**Amendments to the Drawings**

**Remarks**

*Annotated Sheet*

Fig. 11

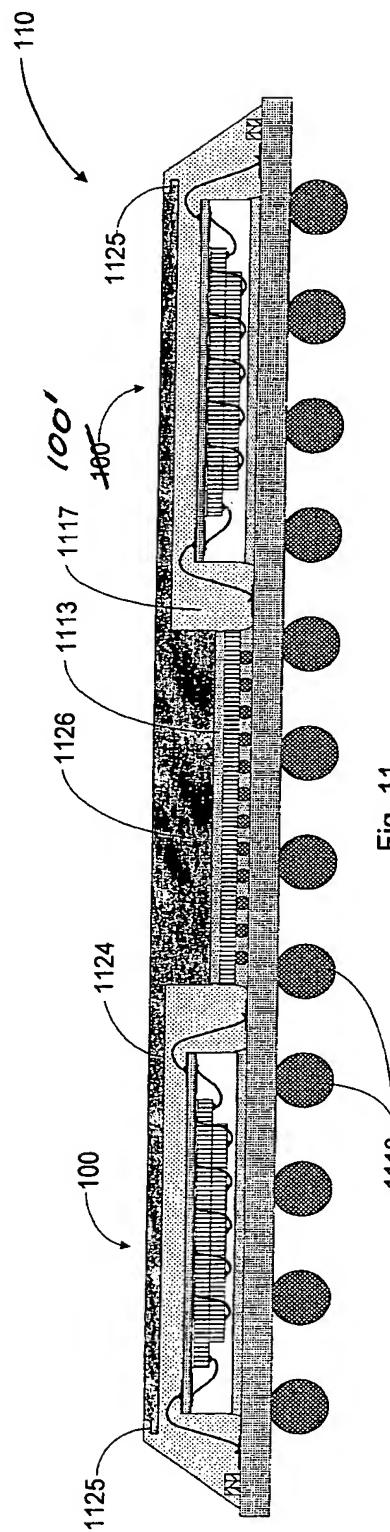
The attached sheet of drawings includes changes to Fig. 11. This sheet, which includes Figs. 10 and 11, replaces the original sheet including Figs. 10 and 11. In Fig. 11, an instance of reference numeral 100 has been changed to 100'.

The drawings were objected to under 37 CFR 1.84(p)(5), the Examiner noting that the drawings include reference characters 721 and 817, which were not mentioned in the description, and that the drawings do not include a reference sign 100'. The specification is amended herein to insert the missing reference characters, and FIG. 11 is amended to change one instance of

reference numeral 100 to 100'. No new matter is introduced by these amendments, and entry thereof is requested.
